Certificate of Appropriateness for 6 Lathrop St

October 14, 2019

Proposed Work

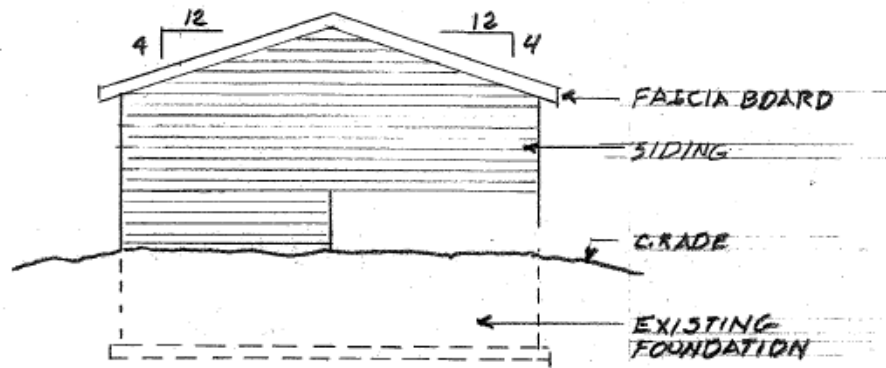
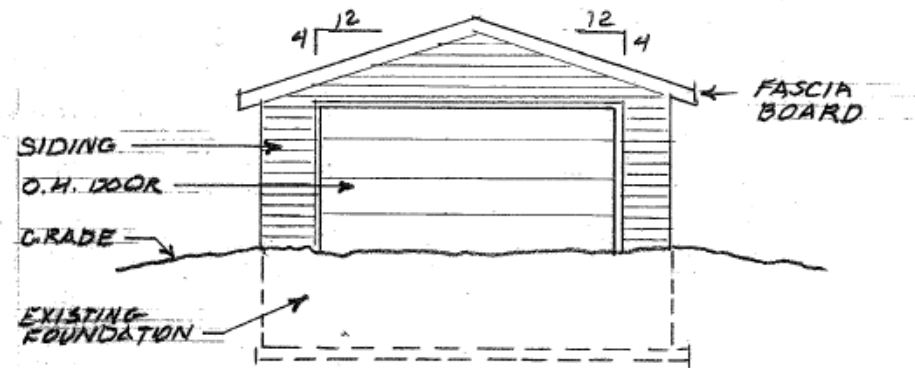
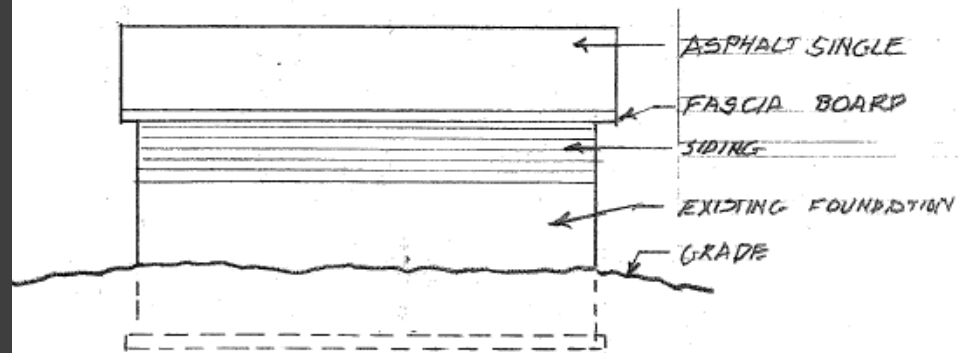
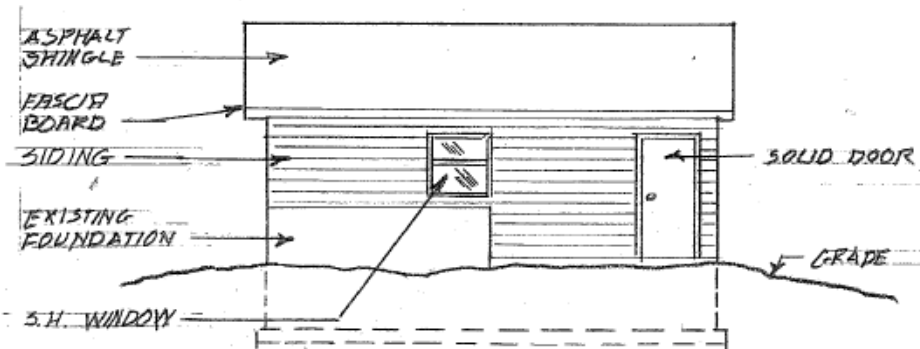
1. Siding and trim specifications to be approved by staff
2. Pedestrian door, garage door, and window specifications to be approved by staff
